Access Compliance Report

Public Rights-of-Way

Intersection ID: 32179	Main Street: AMONTILLADO_DR	Cross Street: MARIE_ROGET_WY	Location: E
ADA ID: BF897F7E25D7	Ramp Type: PerpDiag	Initial Pass/Fail: Fail	Overall Compliance: No
		Severity Score: 17.5

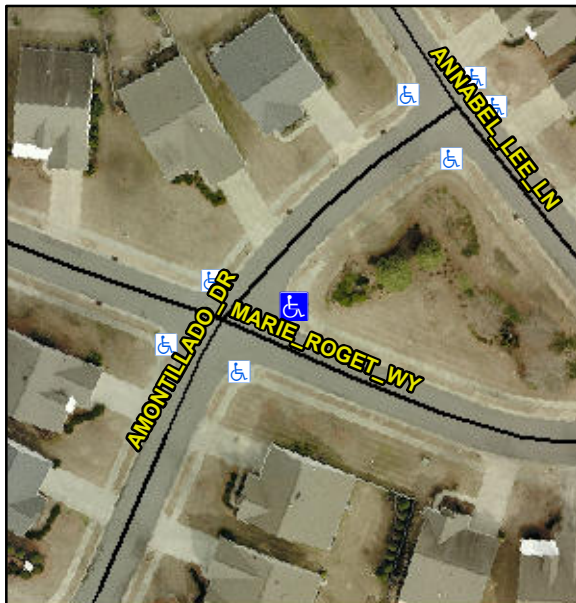
Not Found, R304.5.1

Compliance	Description	Data	Compliance	Description	Data
N/A	Ramp Length (in)	46.0	Yes	Ramp Slope (%)	5.4
No	Ramp Width (in)	35.0	Yes	Ramp XSlope (%)	1.3
N/A	Flare Type LT	N/A	N/A	Flare Type RT	N/A
N/A	Flare Slope LT (%)	N/A	N/A	Flare Slope RT (%)	N/A
N/A	Flare Traversable LT?	N/A	N/A	Flare Traversable RT?	N/A
N/A	Landing Length (in)	N/A	N/A	DWS Provided?	N/A
N/A	Landing Width (in)	N/A	N/A	DWS Contrast?	N/A
N/A	Landing Slope (%)	N/A	N/A	DWS Length (in)	N/A
N/A	Landing X Slope (%)	N/A	N/A	DWS Full Width?	N/A
N/A	Landing Curb? (Y/N)	N/A	N/A	DWS Offset (in)	N/A
N/A	Shared Landing?	N/A			
N/A	Gutter Ponding?	N/A	N/A	Gutter Slope (%)	N/A
N/A	Gutter Lip Ht (in)	N/A	N/A	Gutter X Slope (%)	N/A
N/A	Painted X Walk1?	No	N/A	Painted X Walk2?	No
	X Walk 1 Direction	To NW		X Walk 2 Direction	To SW
N/A	X Walk 1 Width (in)	N/A	N/A	X Walk 2 Width (in)	N/A
	X Walk 1 Slope (%)	0.8		X Walk 2 Slope (%)	0.5
	X Walk 1 X Slope (%)	0.2		X Walk 2 X Slope (%)	1.0

Remove & Replace Curb Ramp With Two New Directional Ramps or Equivalent.
